Re: Response to Conservation Commission Review Comments for NOI  
24 Dustin Road, Reading, MA 01867  
Parcel ID: Map: 26, Parcel: 164

**Table 1: 24 Dustin Road, Reading - Notice of Intent Comment Responses**

**CIVIL PLAN SET  
24 DUSTIN ROAD  
READING, MA**

SITE PLAN

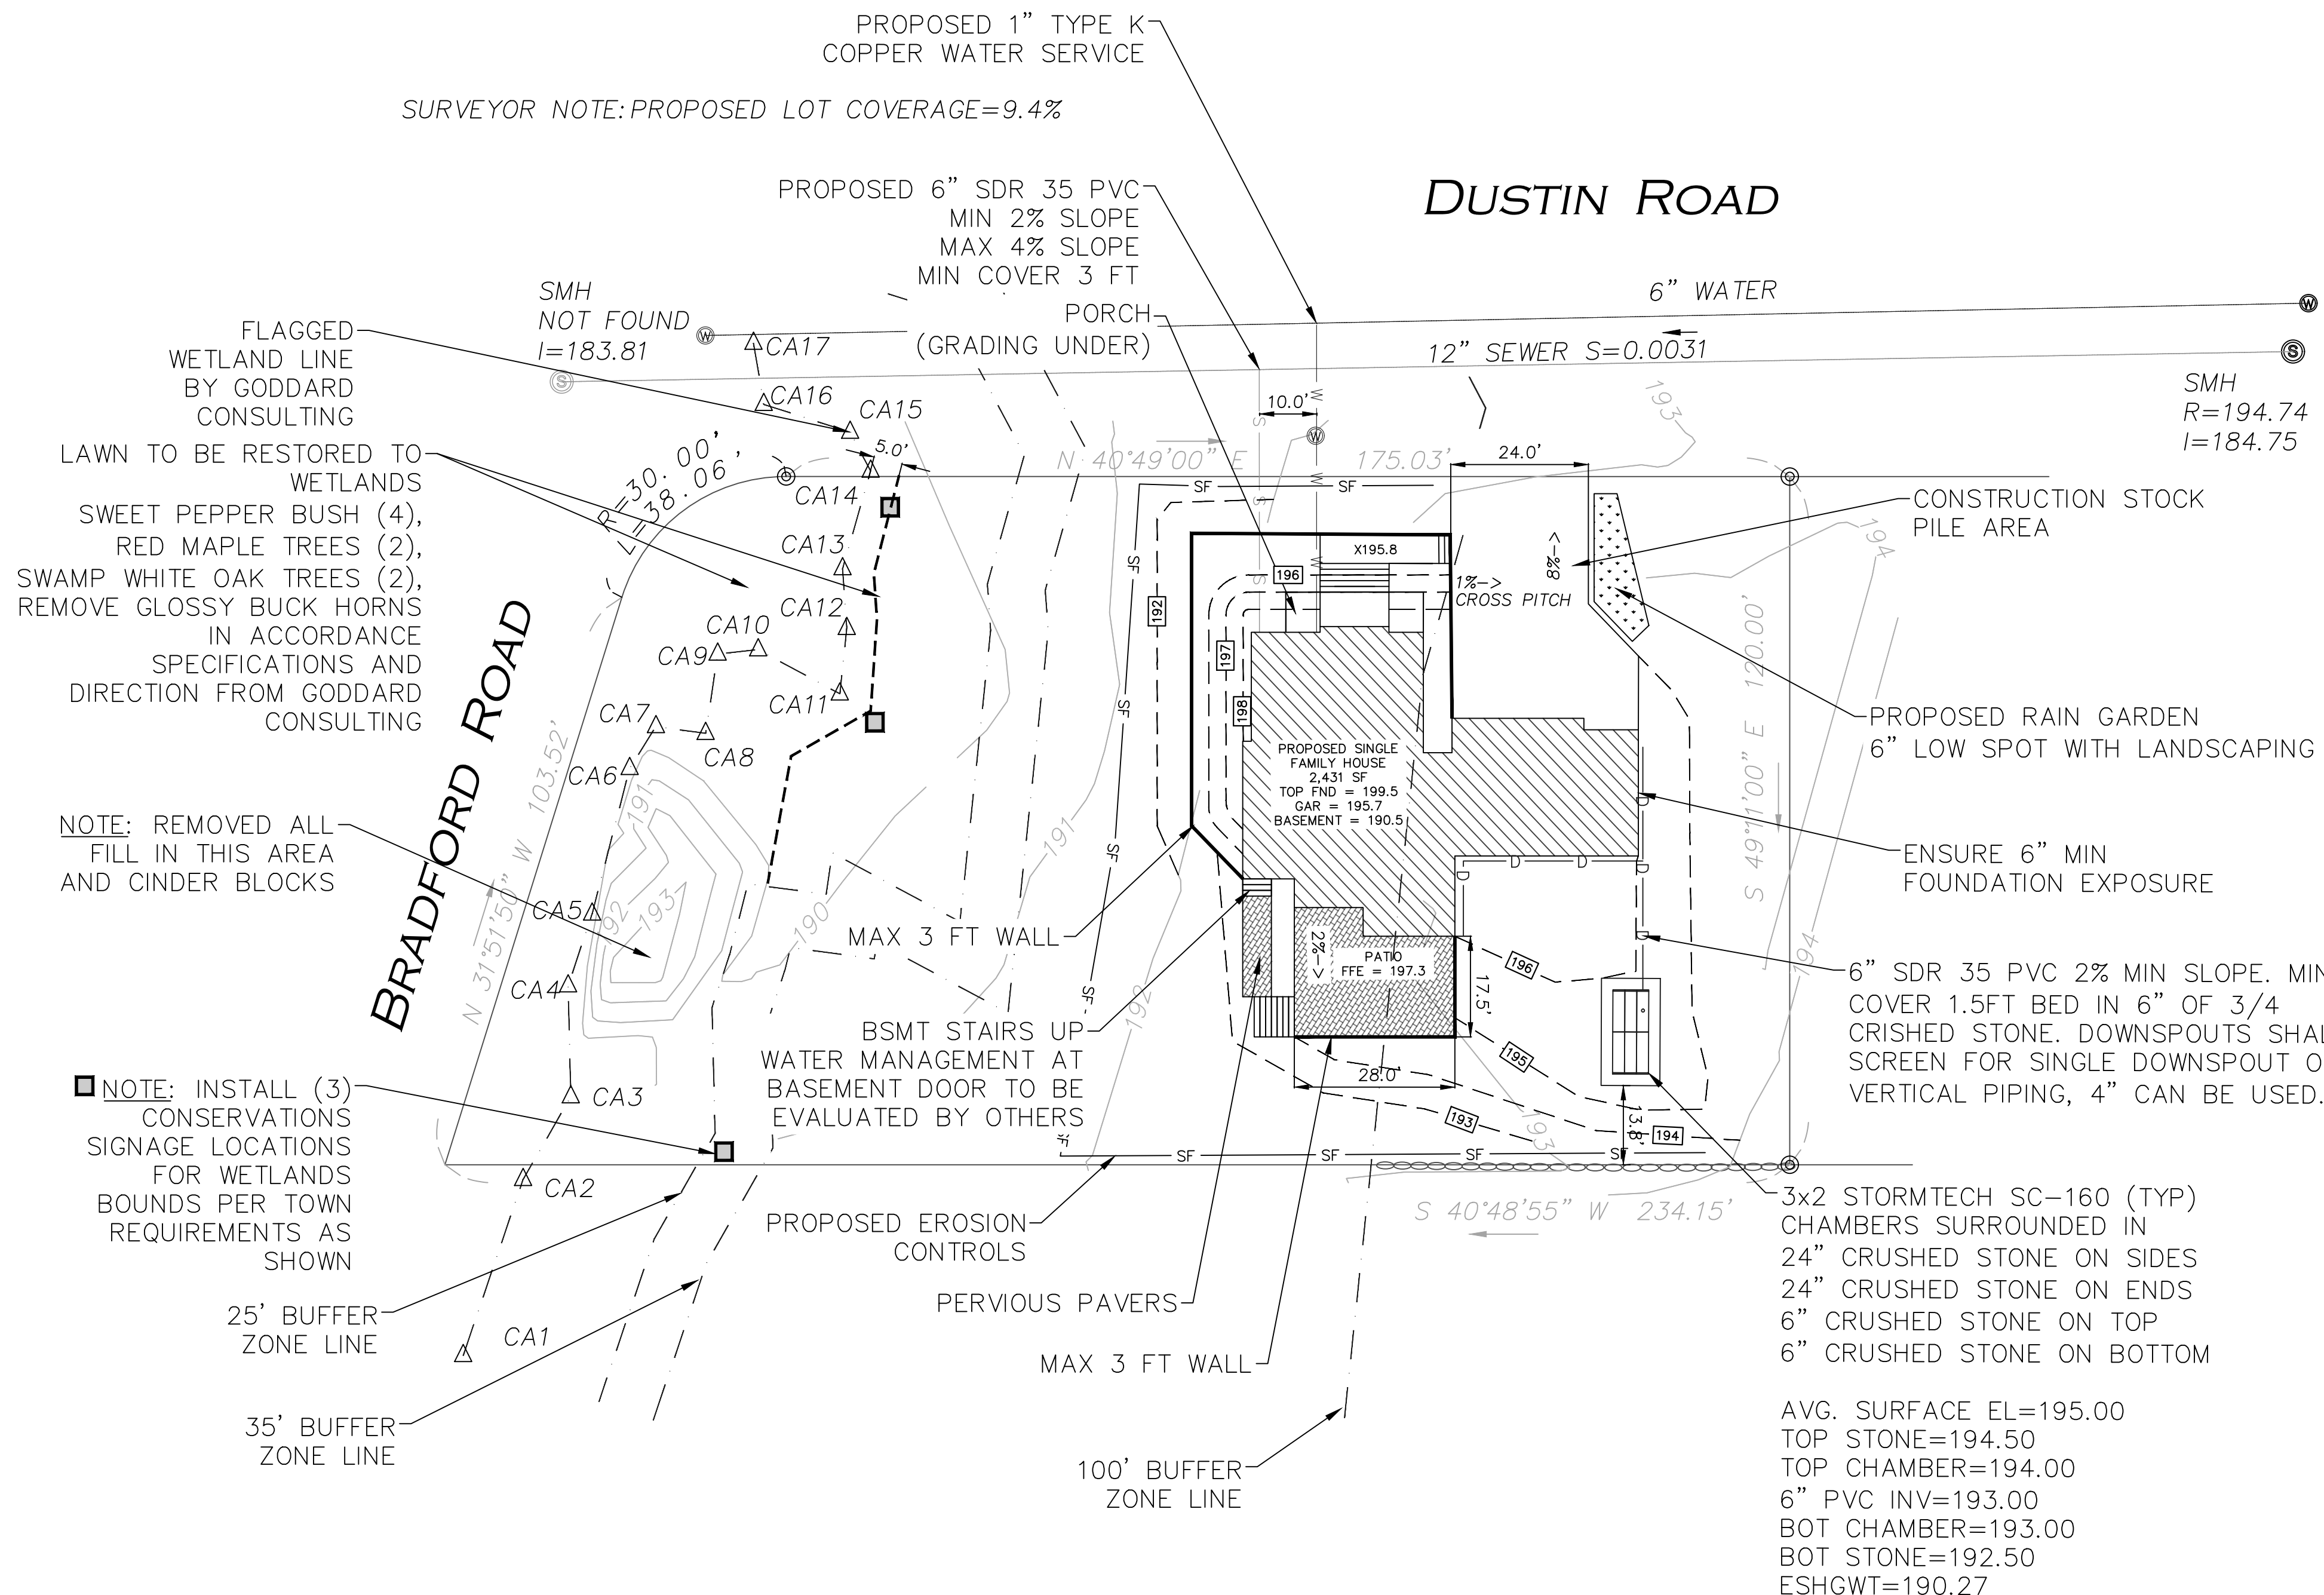
<p>6. The commission requested conservation signage to be installed both along the 25-foot local no disturb zone, or the limit of the restoration areas where applicable.</p>	<p>The project team has revised the plans to include the requested conservation signage in the locations discussed with the Conservation Commission at the 10/8/25 meeting. The plan proposes three signs to be added, located at the limit of the restoration areas upgradient of flags A14, A11, and at the 25-Foot No Disturb Zone above flag A3.</p>
<p>7. Increase the vegetated buffer above the wet lawn area (flags A11 – A14) by about five feet to create a buffer to the restored wetland area.</p>	<p>The project team has revised the plans to increase the vegetated buffer above the restored wetland area. The site plans have been revised to locate the limits of the restoration area an additional five feet upgradient from the original location along the wetland line. Additionally, conservation signage has been located at the edges of the restoration area to protect the area in perpetuity.</p>

<p>8. Increase the plantings within the restored wetland area to include both mitigation for the required tree removal as well as shrub plantings to create a more natural system.</p>	<p>The project team has revised the plans to include additional plantings within the restored wetland area (located below flags A8 to A14). As seen on the revised plans, prepared by Engineering Solutions Group, the area is to be revegetated with 2 red maples, 2 swamp white oaks, and 4 sweet pepperbush shrubs. The trees are</p>

intended to replace the trees within the yard requiring removal, and the sweet pepperbush shrubs have been increased to provide a shrub layer that mimics a natural area. It is anticipated that the herbaceous layer will revegetate swiftly, as the area consists of wetland herbaceous vegetation at present that is unable to take hold due to consistent mowing. The ceasing of mowing and replanting of the area is intended to restore all three vegetative layers.
--	--

**MULCH SOCK TUBES & SILT FENCE FOR EROSION CONTROL**

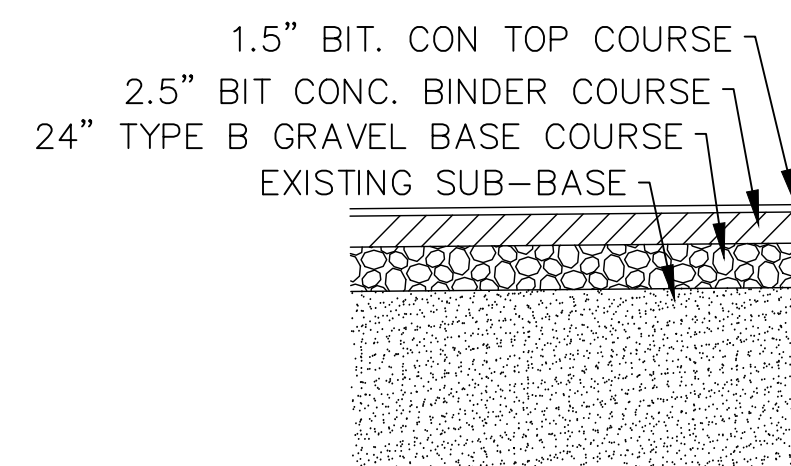
<p>3. The commission requested the use of mulch socks as erosion controls instead of straw wattles.</p>	<p>The project engineer, Engineering Solutions Group, has revised the site plan details to incorporate mulch socks instead of straw wattles. The erosion control locations remain the same.</p>
<p>4. The commission requested a stockpile area be added to the plans.</p>	<p>The project engineer, Engineering Solutions Group, has revised the site plans to display a stockpile area. The stockpile area has been located within the area of the driveway to site the stockpile outside of the Buffer Zone, and to place materials within an area to be developed so as to avoid additional impacts associated with the storing of materials.</p>
<p>5. The commission requested that subsurface stormwater management be added to account for the increase in impervious surface coverage generated by the new house.</p>	<p>The project engineer, Engineering Solutions Group, has revised the design of the project to include subsurface stormwater management. The project now proposes subsurface Stormtech SC-160 Chambers to the southeast of the house to handle roof runoff, as well as a rain garden in the northeast portion of the site adjacent to the proposed driveway.</p> <p>A test pit was conducted in the location of the proposed Stormtech chambers, confirming well-draining, fine sandy loam soils, and an estimated seasonal high groundwater table at 190.27'. The system has been sized to handle 1" of runoff for all impervious surface increases generated by the project. Drainage calculations have been added to the site plans to display that the storage volume designed exceeds the 1" storm as required by the Town of Reading. At the request of the commission, an O&amp;M plan has additionally been submitted to ensure the long term maintenance of the system.</p>
